CHANGE ORDER PROPOSAL FORM

COP #__1___

1477E – Main D Extension	City of Stevenson
Project Number	Owner
3/1/2022	Jane Vail
Contract Date	Owner's Representative
Jeff Pettenger, Project Manager	Carolyn Sourek, Public Works Director
To	Copies To

CITY OF STEVENSON MAIN D EXTENSION

DRAWING NO:
C5

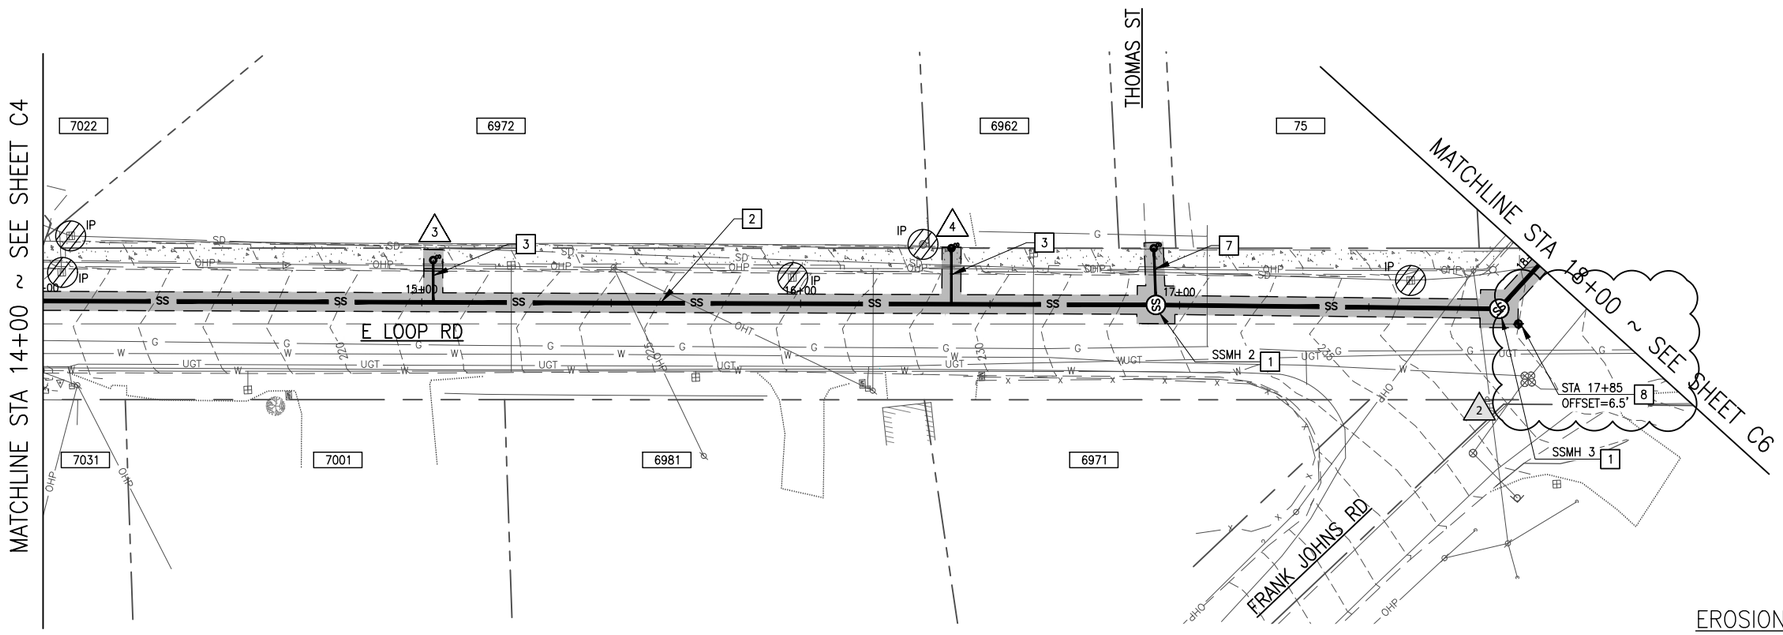
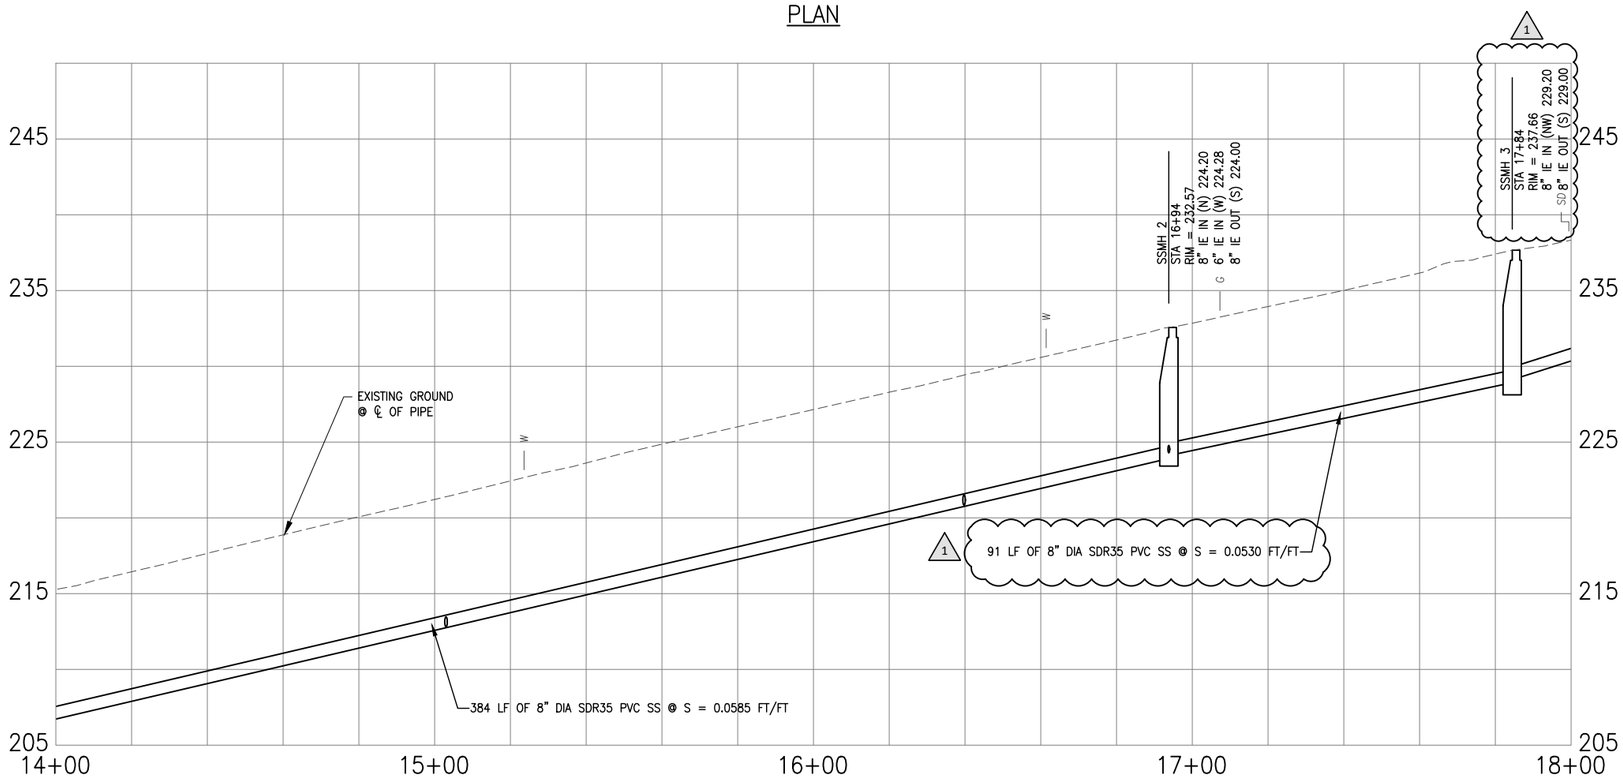
Resetting two monuments if disturbed by pavement restoration work at Stations 17+85 and 20+20.

Increasing the quantity of Bid Item No. 11 – Sewer Manhole, 48 In. Diam. from 3 each to 4 each, in order to correct a discrepancy between the contract plans and the bid schedule.

1. INSTALL NEW 48" DIAMETER CONCRETE SANITARY SEWER MANHOLE PER DETAIL, SHEET D1.
2. INSTALL PVC SANITARY SEWER MAIN OF LENGTH AND DIAMETER NOTED.
3. CONSTRUCT NEW 6" DIAMETER PVC SANITARY LATERAL AND CLEANOUT PER DETAILS, SHEET D2. SEE TABLE BELOW FOR LATERAL DATA. STAMP "S" ON THE CURB AT THE LOCATION OF THE SERVICE LATERAL.
6. PROTECT EXISTING MONUMENT.
7. CONSTRUCT NEW 15 LF 6" DIAMETER PVC SANITARY SPUR LINE AND MAINLINE SEWER CLEANOUT PER DETAILS, SHEET D2. MAINTAIN 6' MINIMUM DEPTH AND 2% MINIMUM SLOPE.
8. RESET AND RECORD EXISTING MONUMENT.
